Notice of Energy Code Objections

Applicant:	Date: 3/2/17
WIEPKE DAVID JANSEN	Job Application #: 121328205 DOC# 10
AAI ARCHITECTS, P.C.	Application Type: ASHRAE 90.1/ 2007 - NB
14 WALL STREET NEW YORK NY 10005	Premises Address: 217 West 57 th Street
NZIGOMANIS@ADAMSON-ASSOCIATES.COM	Zoning District:
416-967-1500	Block: x Lot: x
NYC Department of Buildings Examiner: Bruce R. Kahle, AIA bkahle@buildings.nyc.gov

REVIEW OF 2/16/18 Set with 3/29/17 Approved set for ENERGY CODE AUDIT: OPEN ISSUES 06/22/2015

DWG No. A-802.01

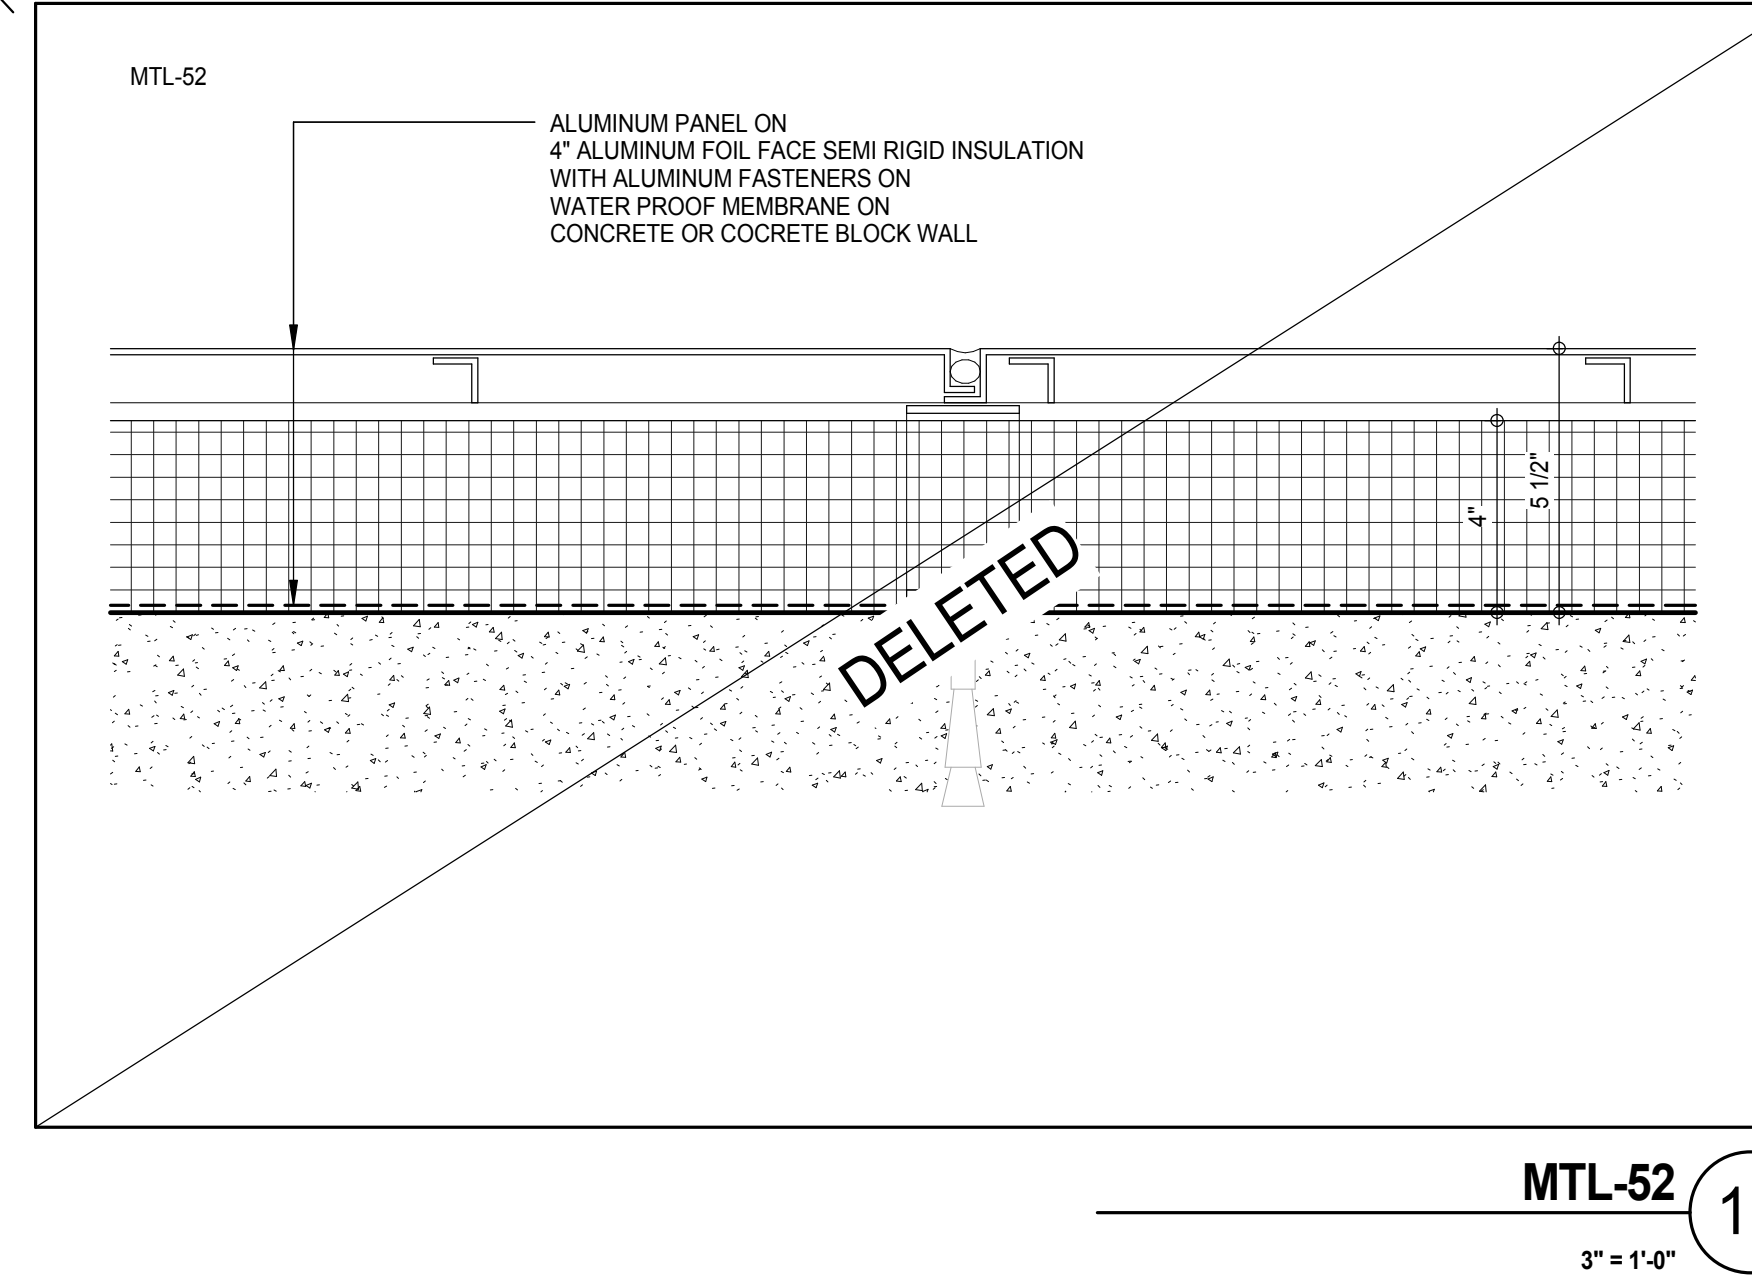
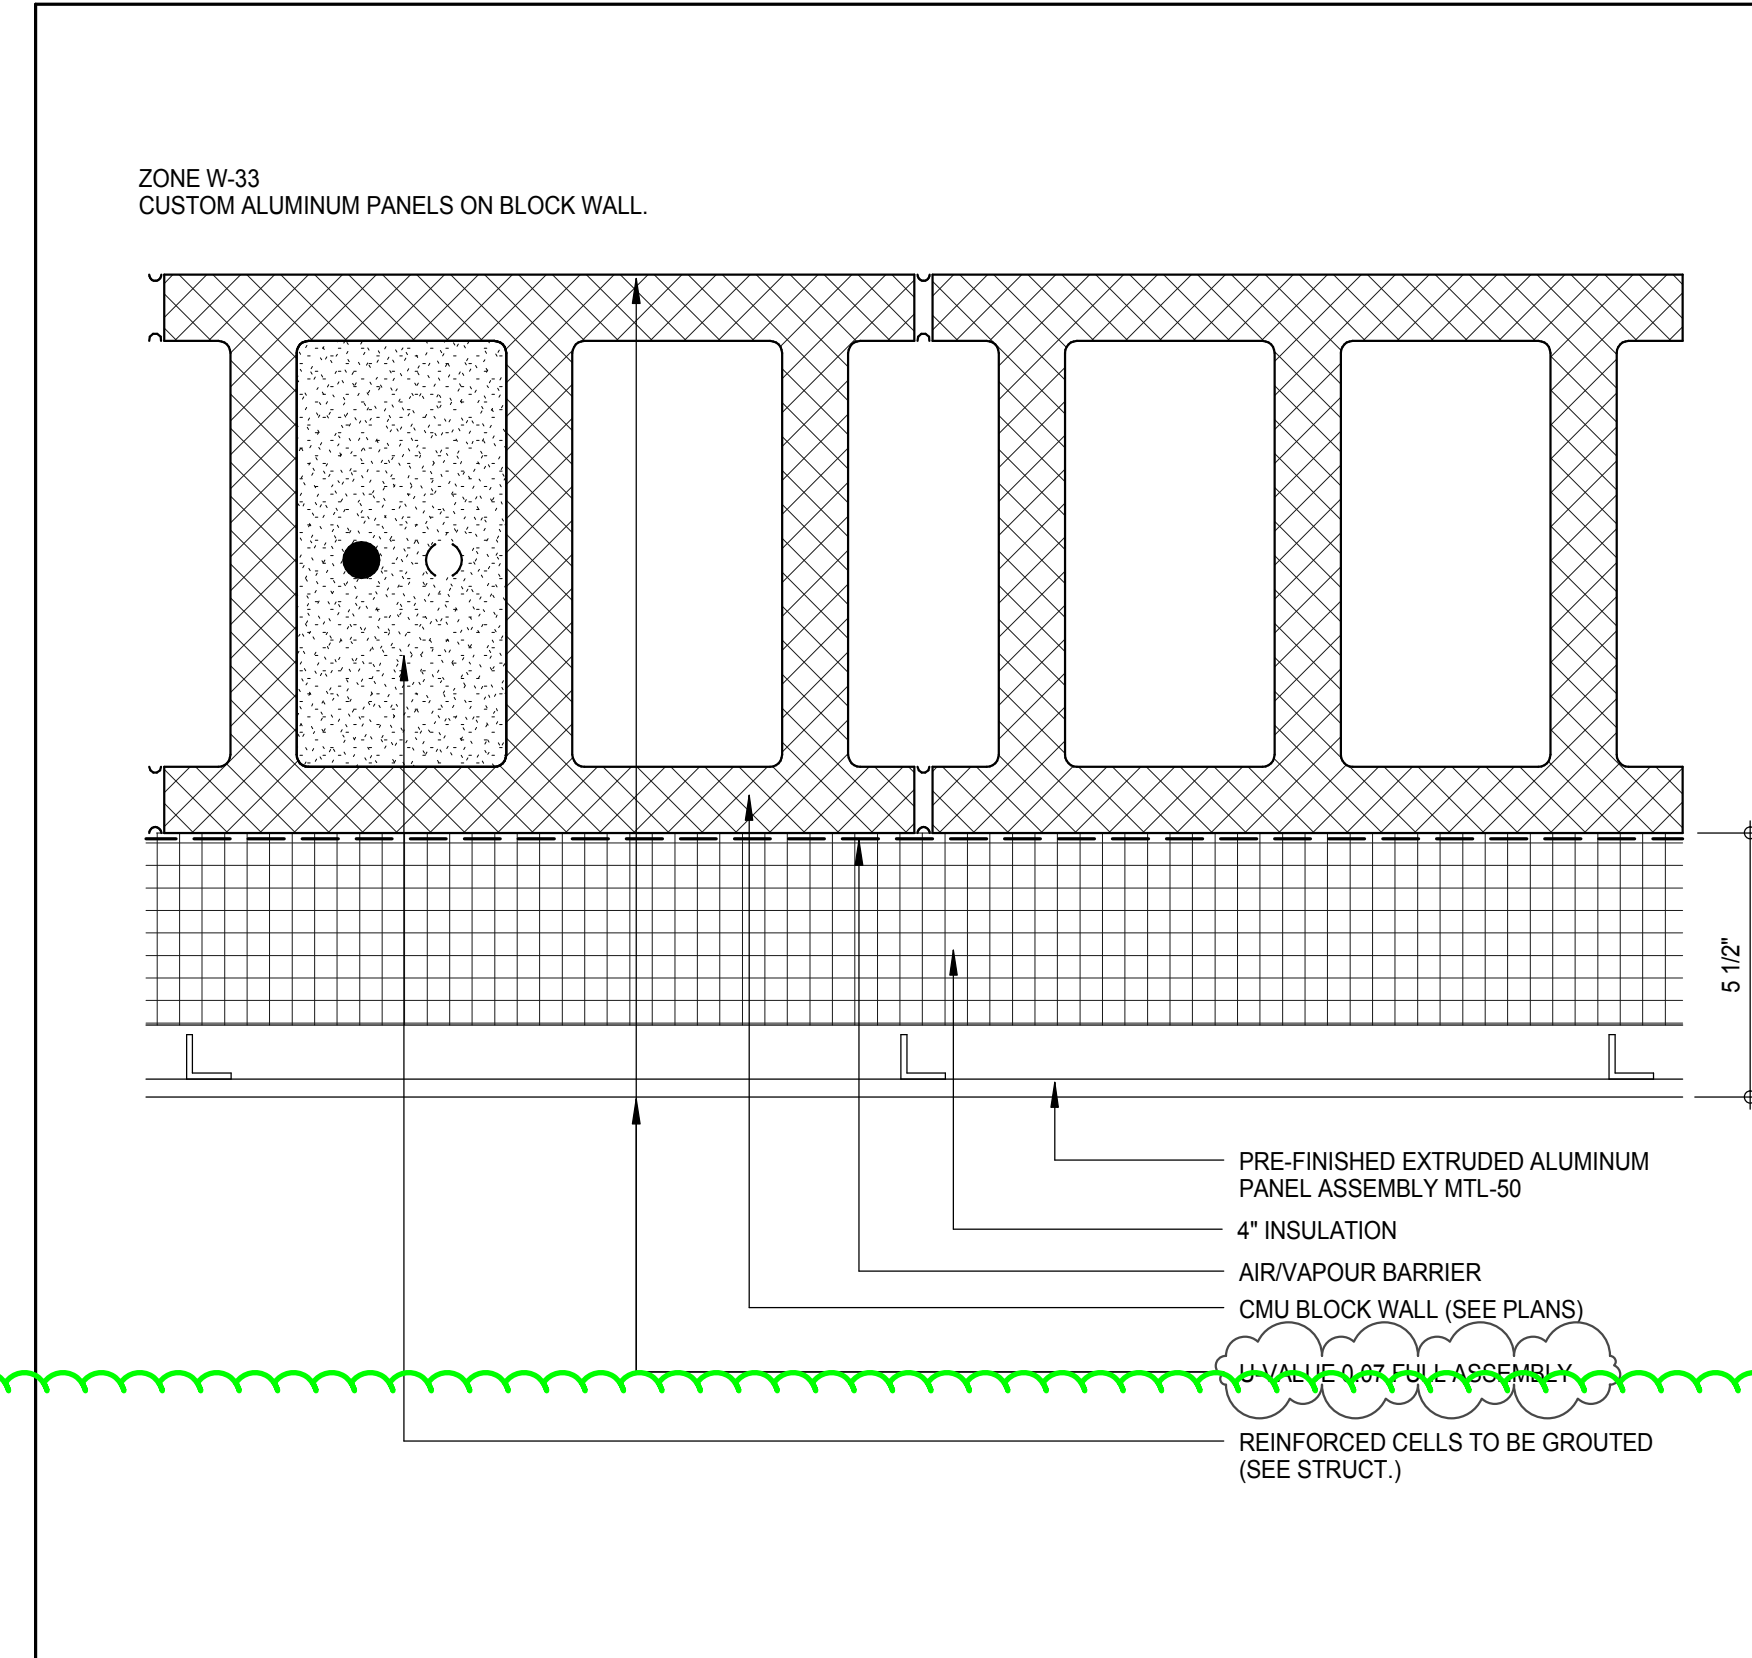
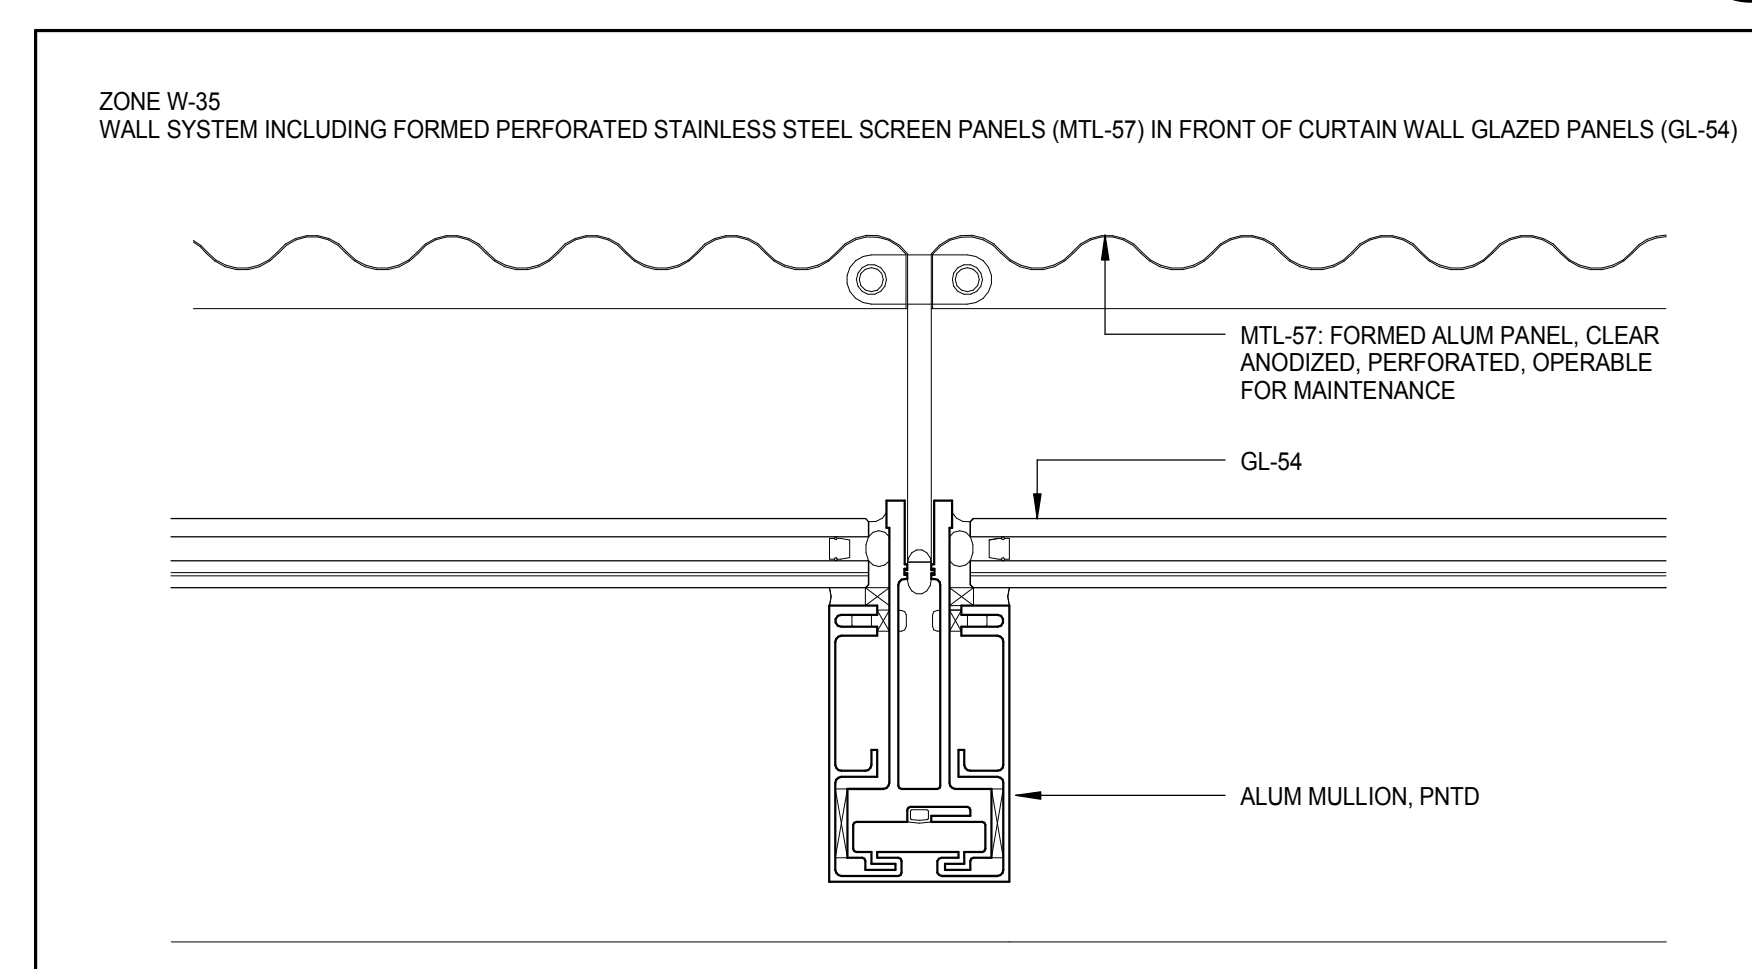
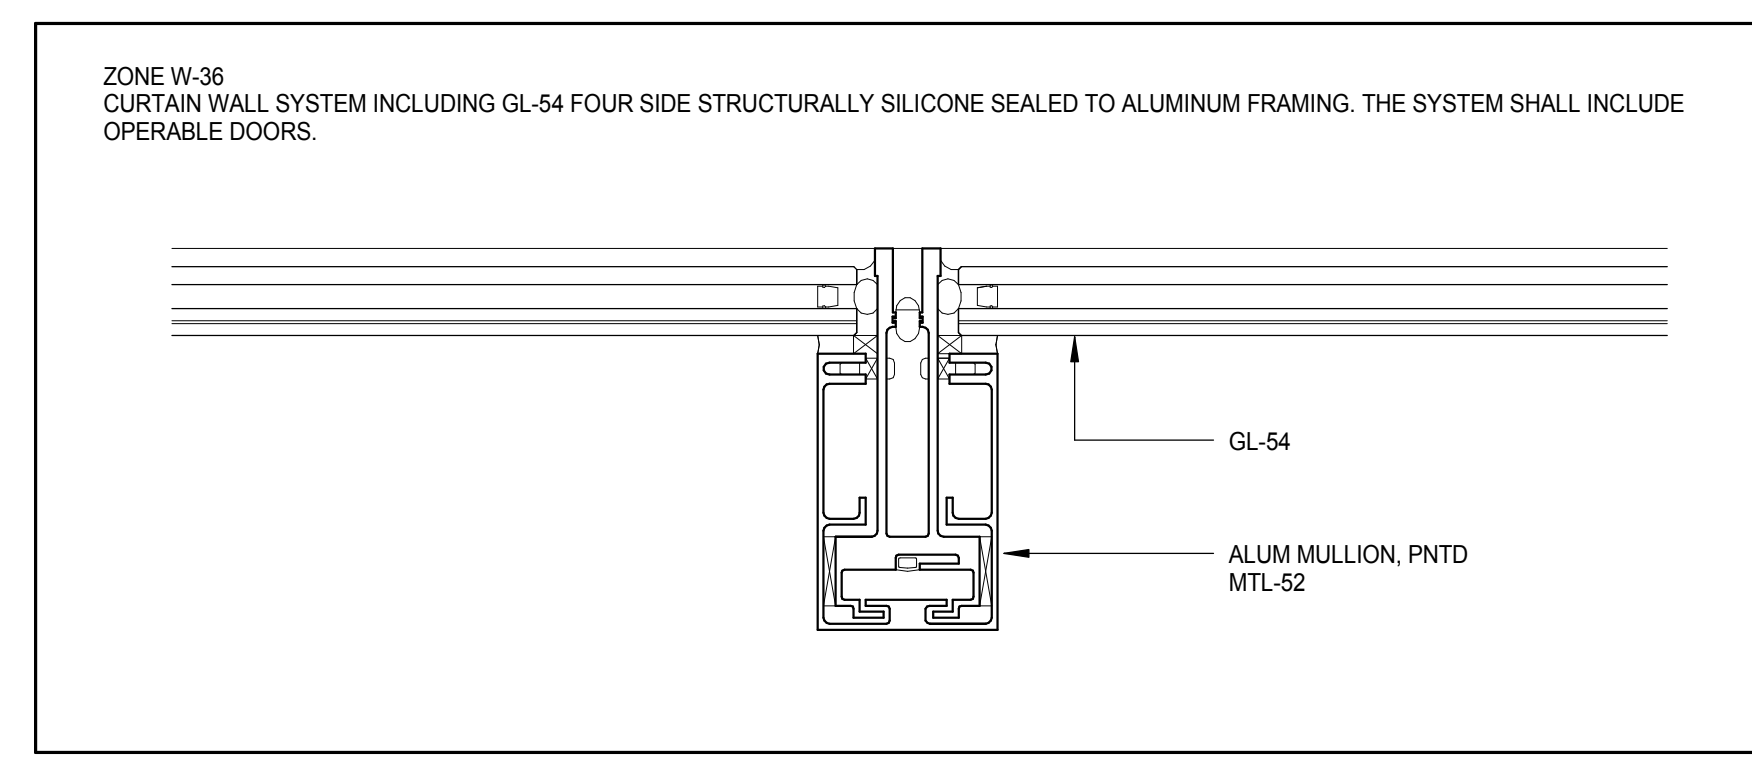
5)		1 RCNY §5000-01(g)(1); 5.4.1	Drawings do not indicate insulation R or U values for below and above grade walls and wall assemblies slabs on grade, floors and roof assemblies to match Energy Analysis.		Comment on A-802.01

6)		1 RCNY §5000-01(g)(1); 5.4.2, 5.8.2	Provide U-factor and SHGC fenestration values in drawing schedules to match or be less than those provided in the Energy Analysis.		Comment on A-802.01

7)		5.4.3	Drawings do not specify mandatory provisions for air leakage, including where applicable, building envelope, fenestration and doors, loading dock weatherseals, and vestibules.		Comment on A-802.01

C402.4 Air leakage
 Drawings do not specify mandatory provisions for air leakage, including where applicable, fenestration systems, outdoor air intake and exhaust dampers, loading dock weathertight seals, vestibules and recessed lighting seals in the thermal envelope.
